Name of Proposed Subdivision CHANDLERS LANDING - PHASE 17

FILE PLAT					CHANDLERS LANDING ROCKWALL COUNTY, TEXAS
PHASE SEVENTEEN					
DESIGN: R.W.S.	DRAWN: C.P.	SCALE: AS NOTED	DATE: MAR., 1984	SHEET: 1 OF 5	POE & ASSOCIATES OF TEXAS, INC.

RE: Final Plat  
Chandlers Landing - Phase 4 & 17

RE: Chandlers Landing - Phase 17  
ROK 84804

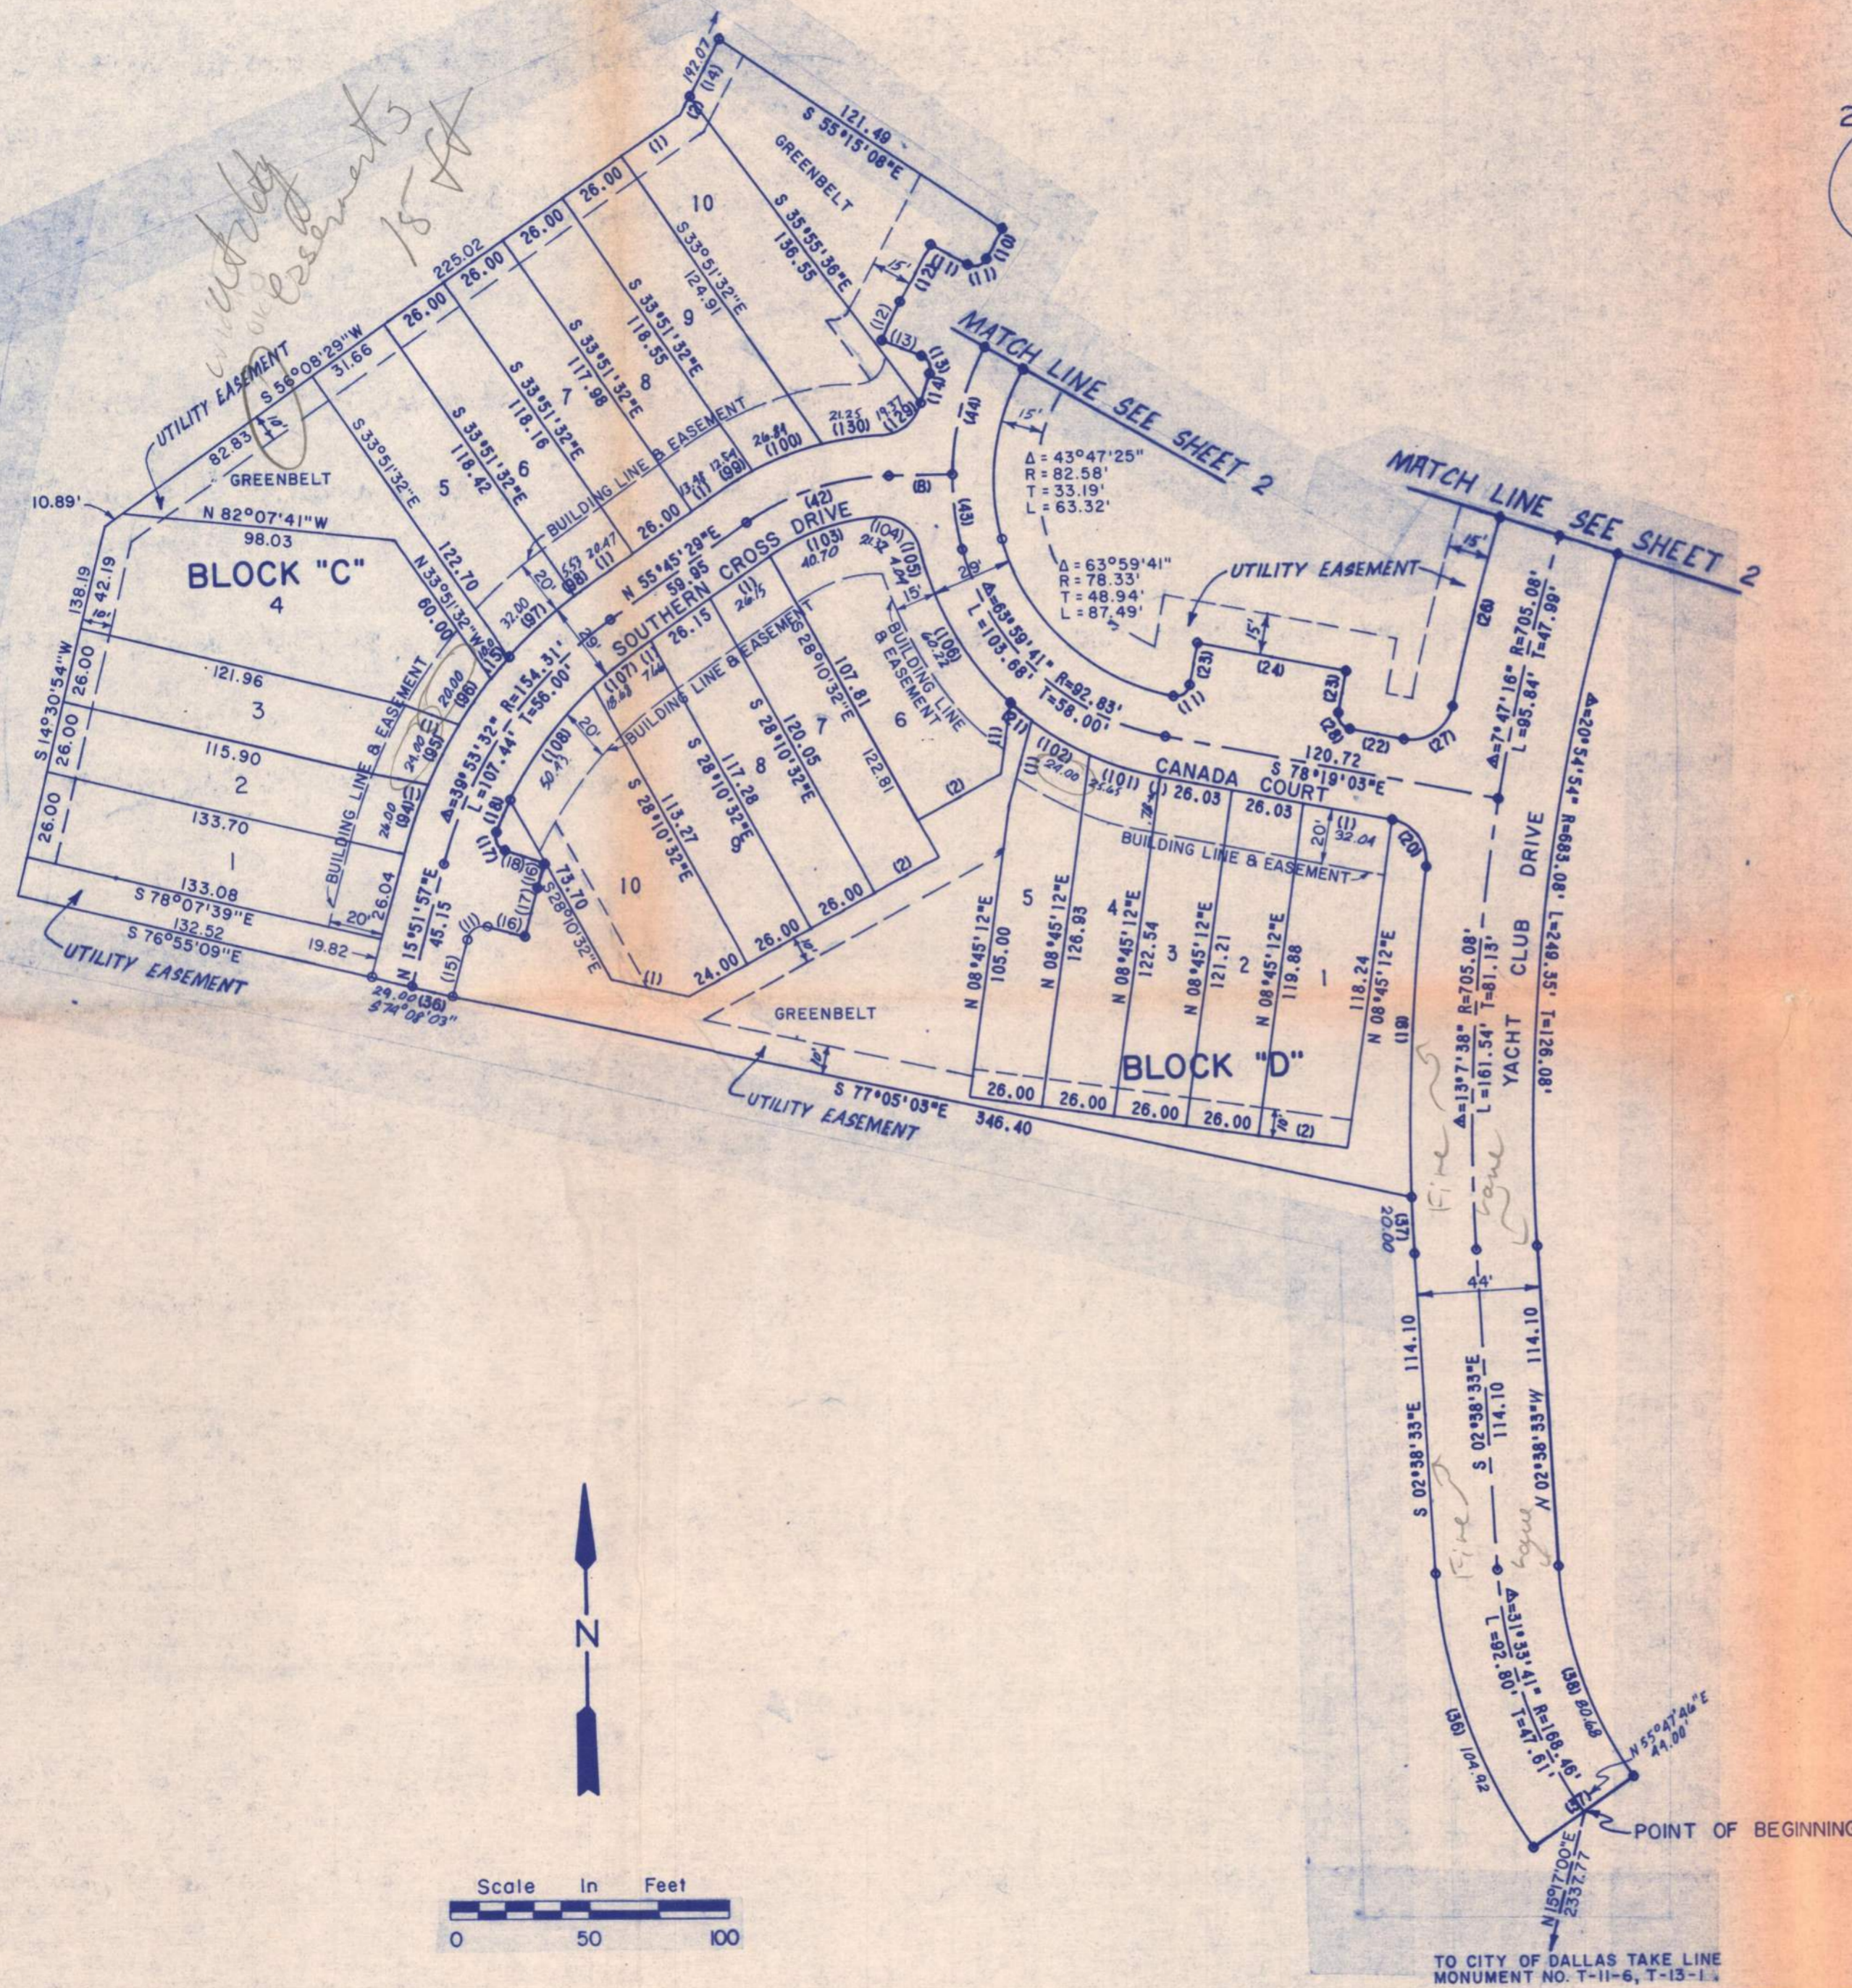
*no note on yacht drive*

*greenbelt and plain*

1. easement widths
  2. field notes - 2 errors
  3. extra two lots from preplan
  4. fire lane 20
  5. access to sewer lift station
  6. force main easement
- MAR 13 1984

<b>FILE PLAT</b>				
<b>PHASE SEVENTEEN</b>				
DESIGN: R.W.S.	DRAWN: C.P.	SCALE: AS NOTED	DATE: MAR., 1984	SHEET: 2 OF 5

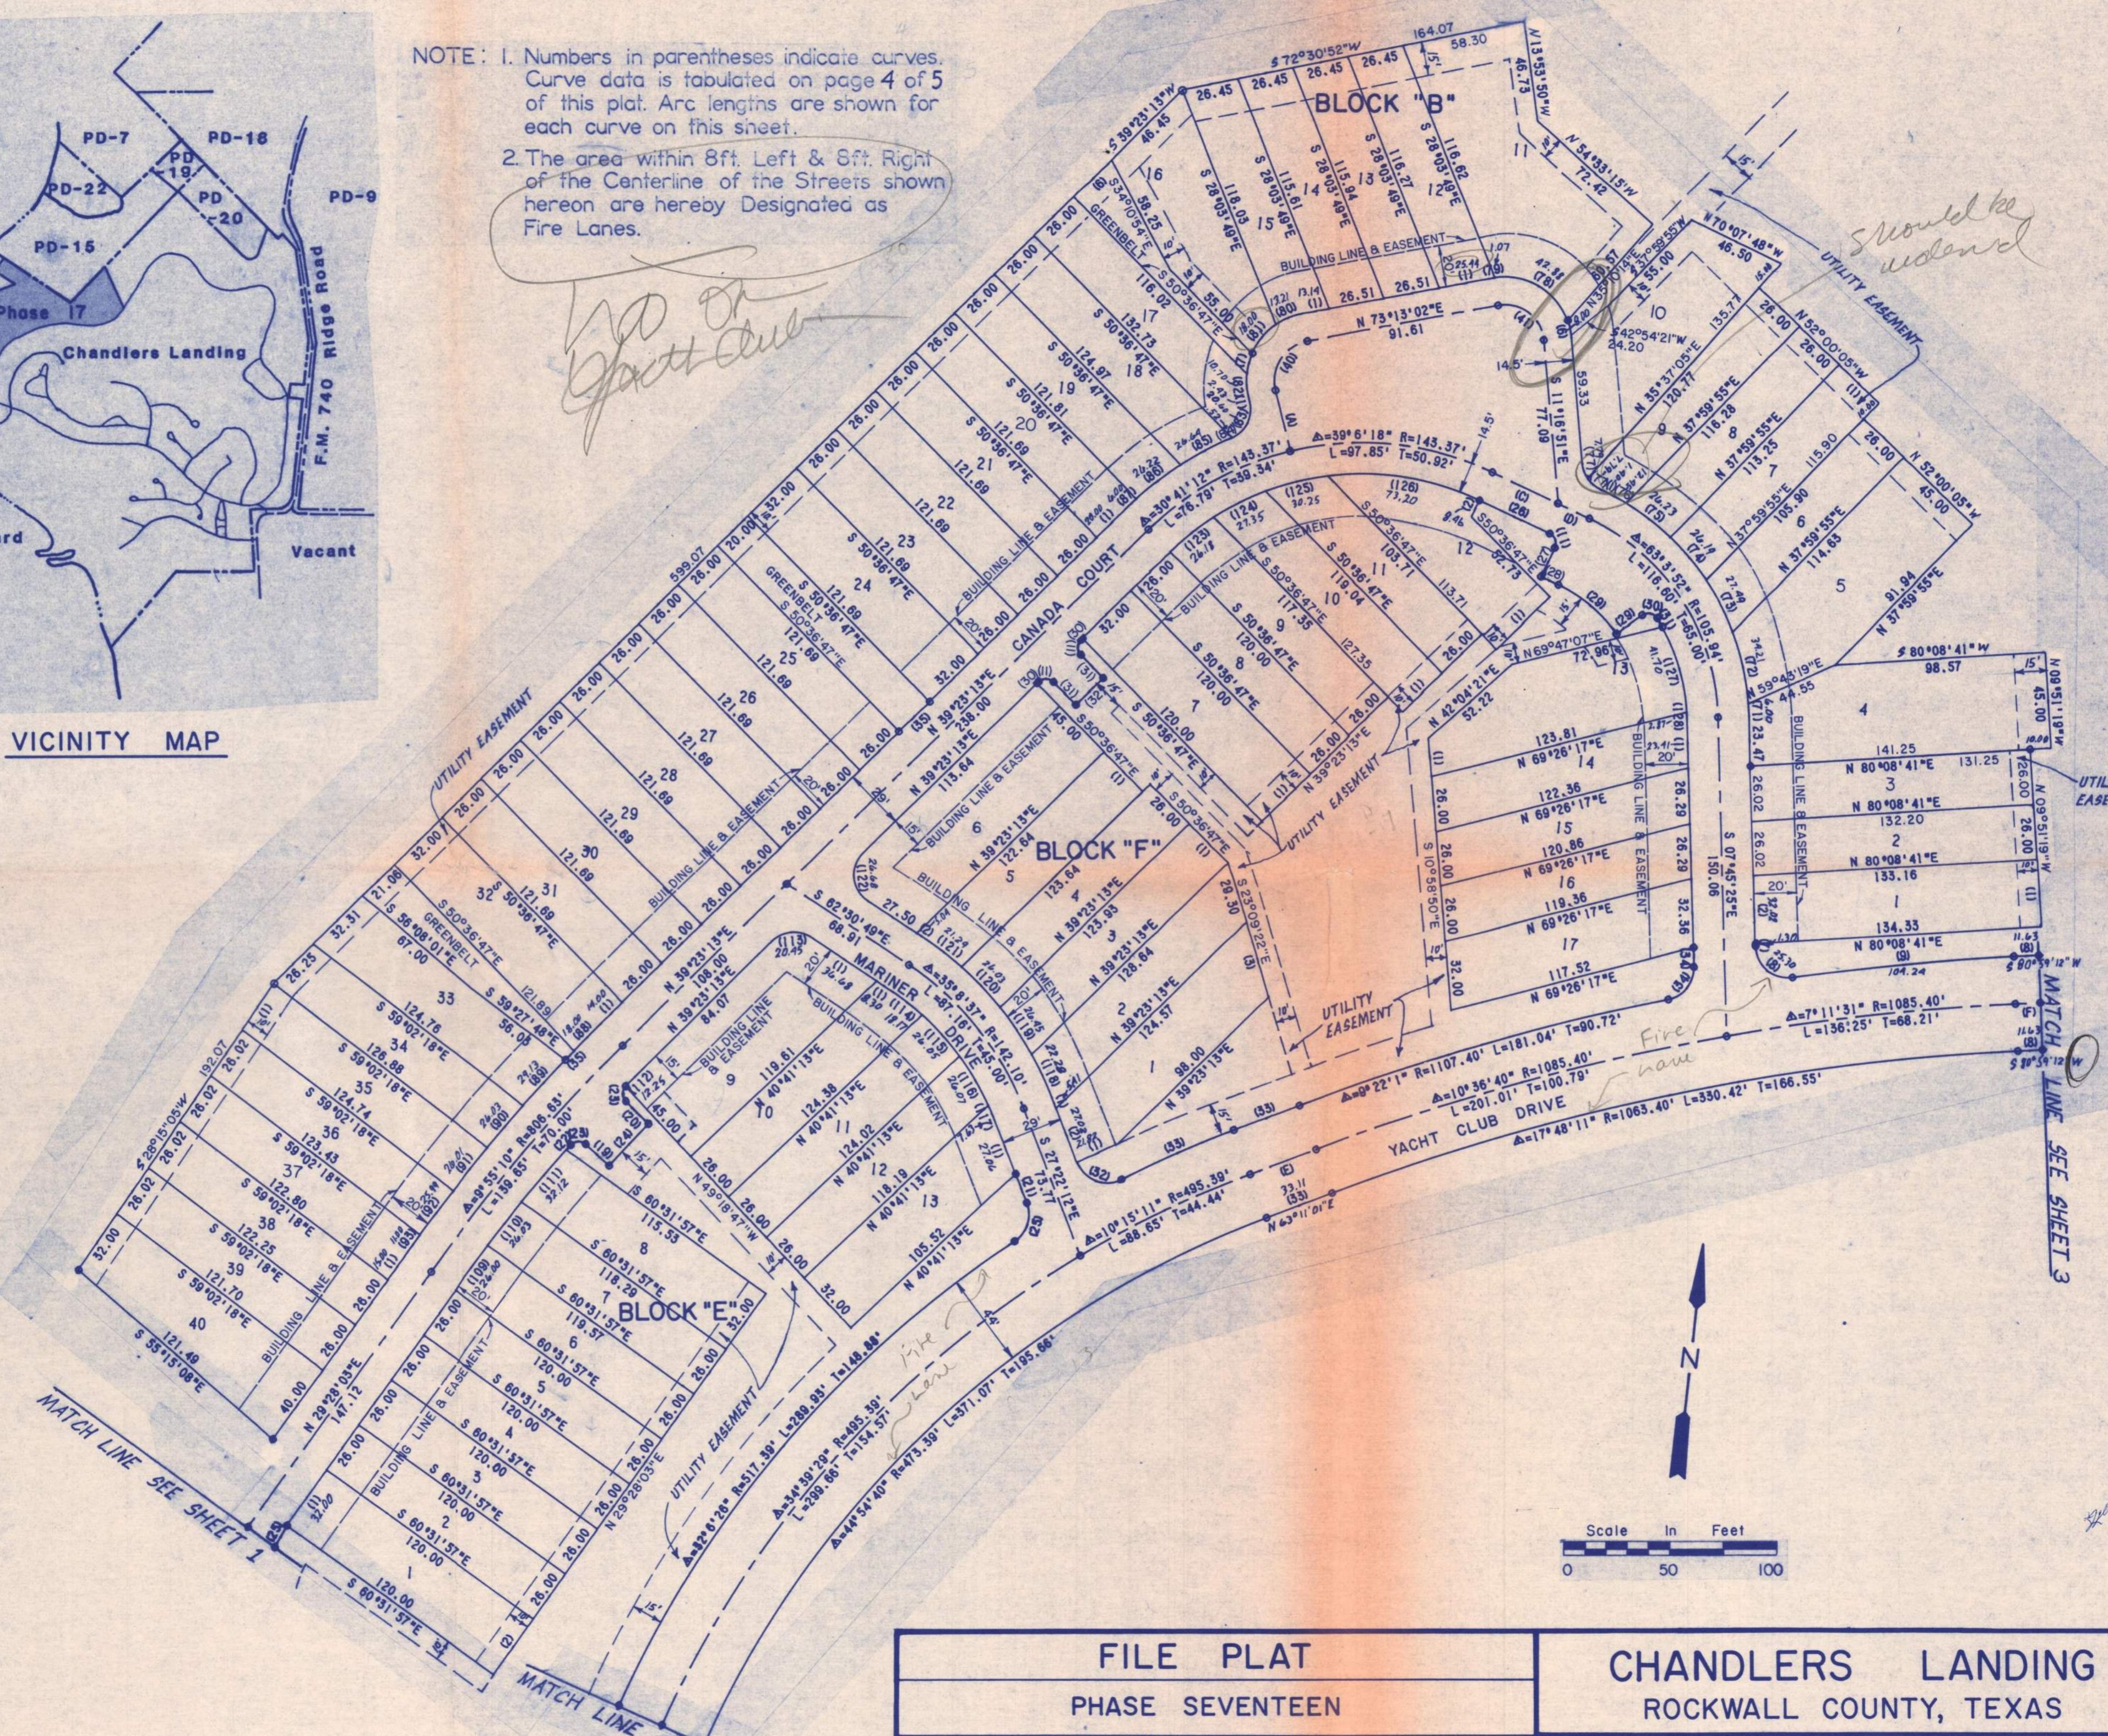
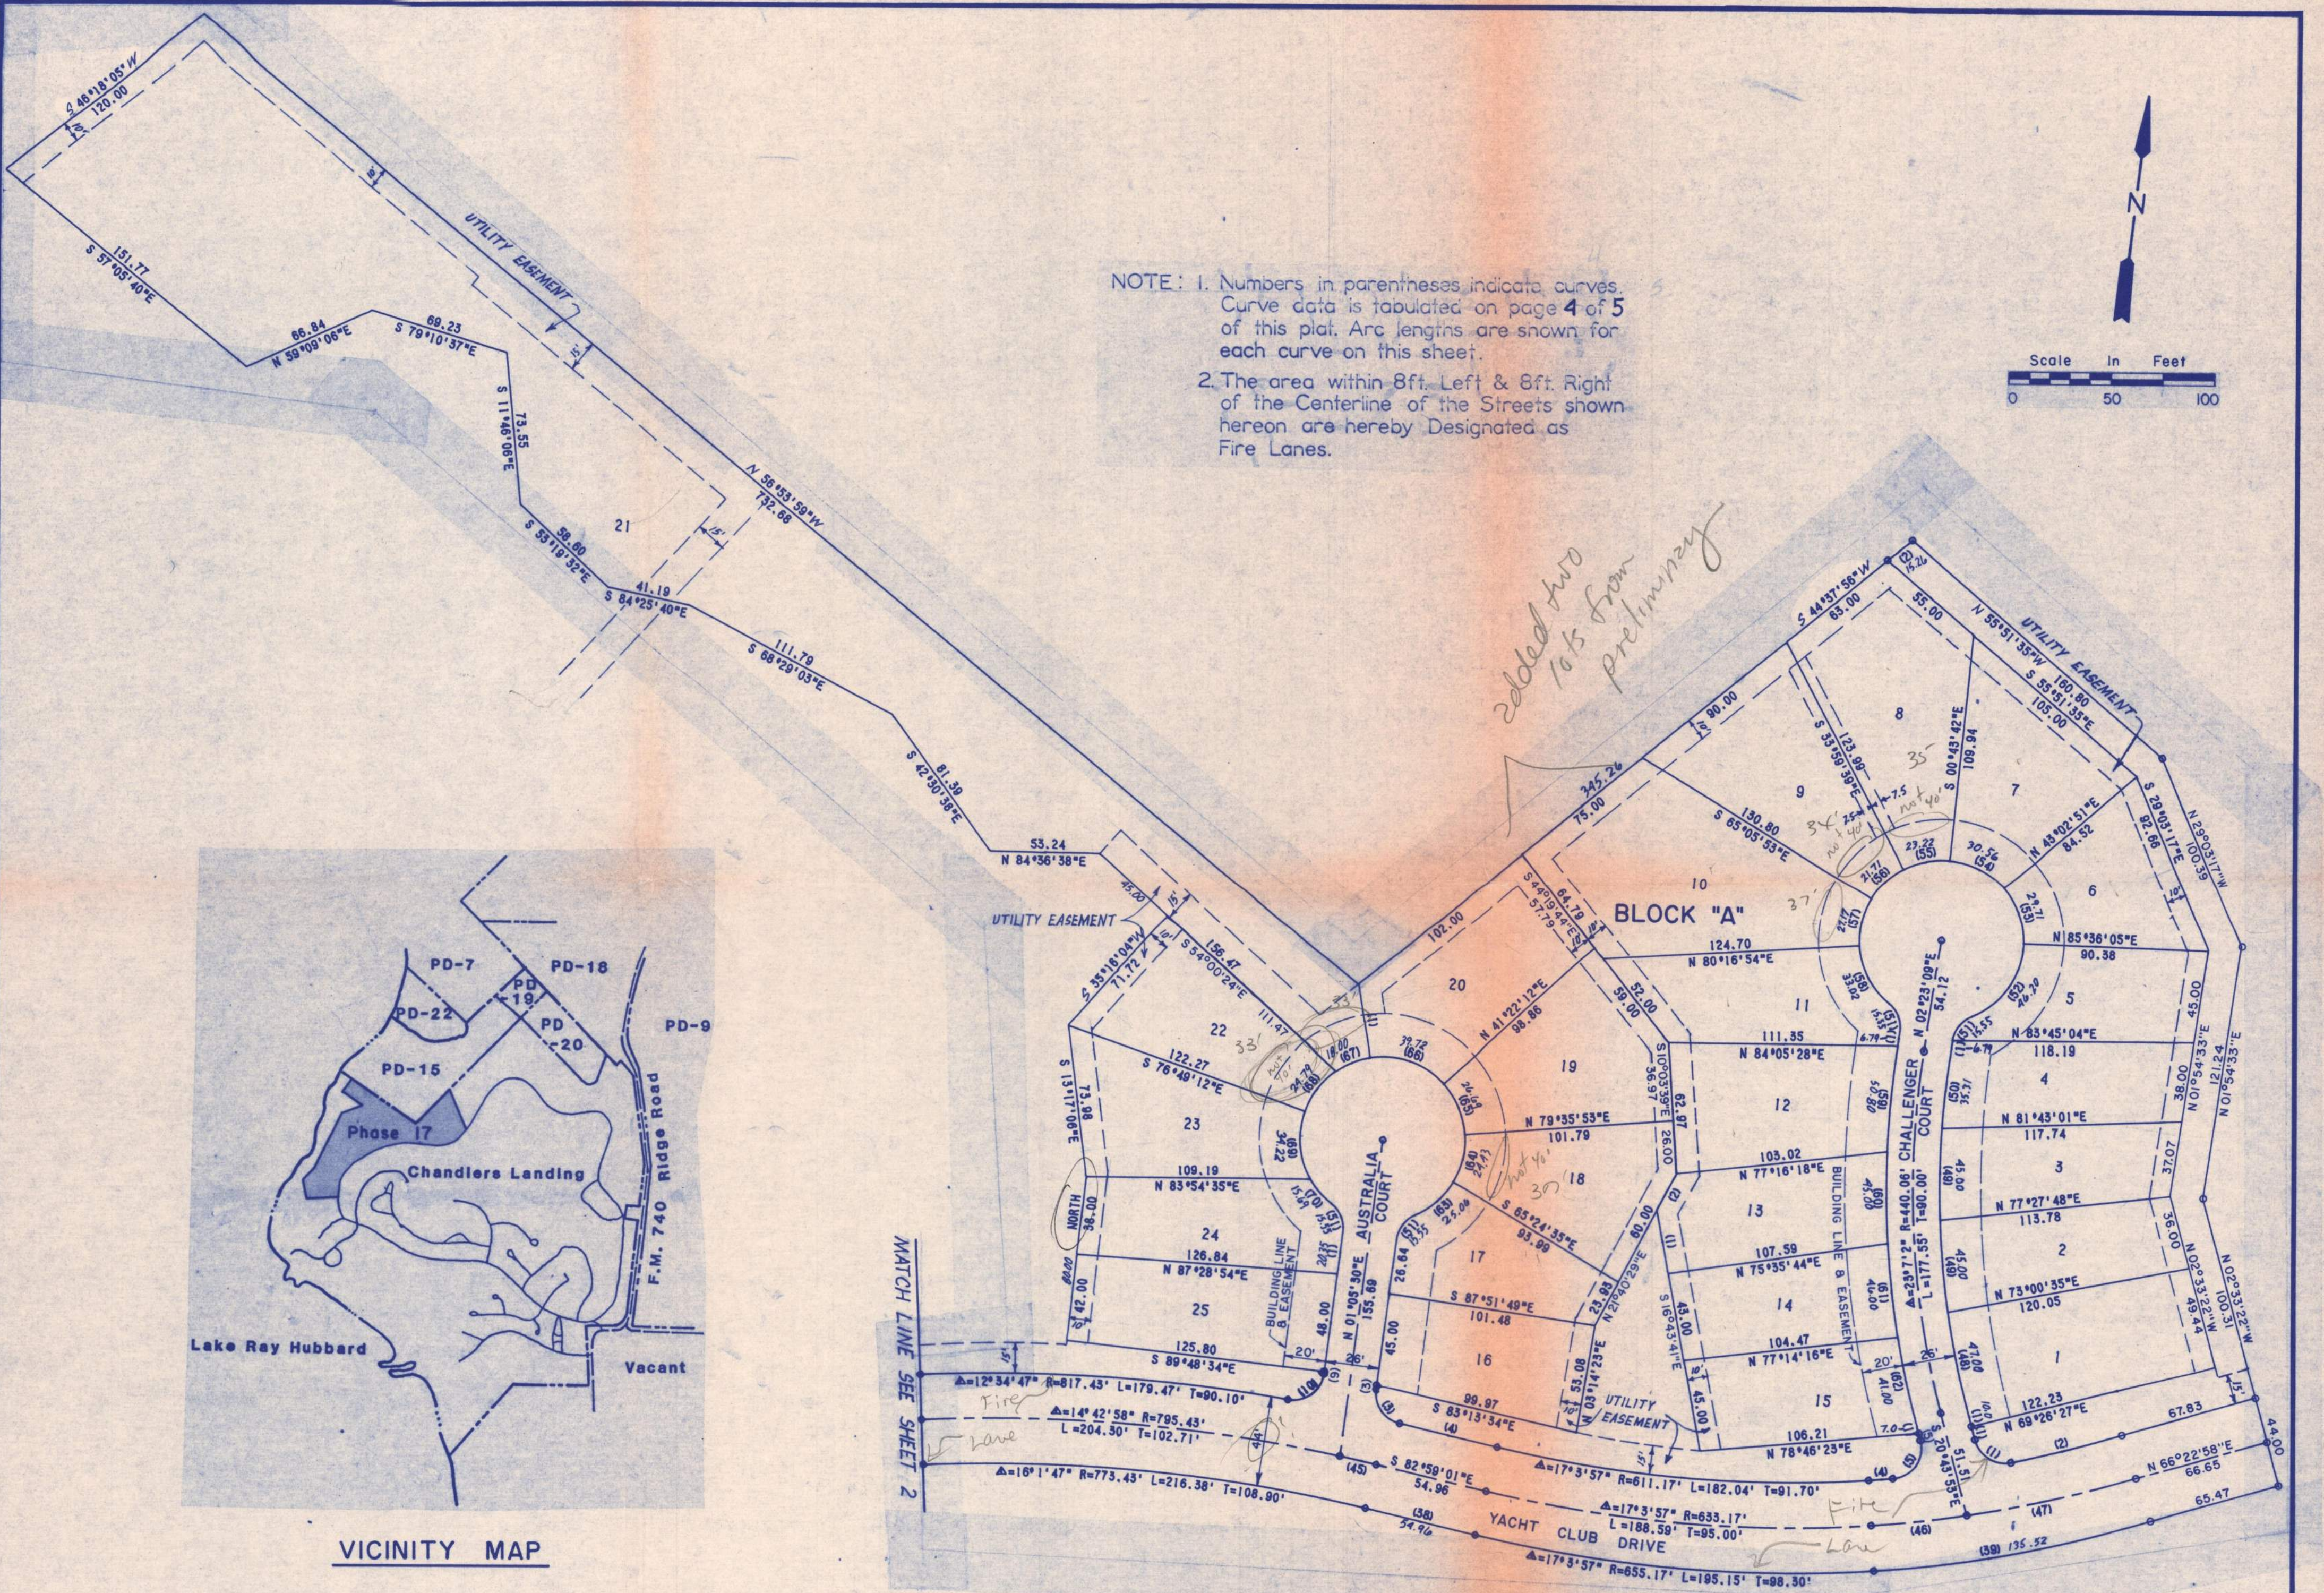
*80 ft. Fire Lane*

*Should be widened*

*Fire Lane*
